Ignition Switch Malfunction Causes Multiple Symptoms

Product: Groundsmaster® 360

April 27, 2012

(Revised- new part number)

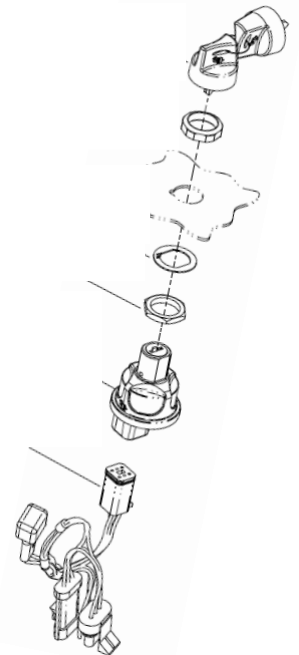
Several electrical issues have been found to be caused by malfunction of factory-installed Ignition Switch ASM, including:

- Constant or intermittent failure of factory-installed Ignition Switch ASM
- Unintentional engagement of the engine starter or starter overheat/failure while key switch is in the Run position
- Intermittent flickering of glow plug and/or diagnostic lights
- Failure of Stop Solenoid
- Damage/overheating of Wire Harness

If any of the above referenced conditions are experienced, the factory-installed Ignition Switch Assembly must be replaced with updated Ignition Switch ASM (121-5357) to correct the issue.
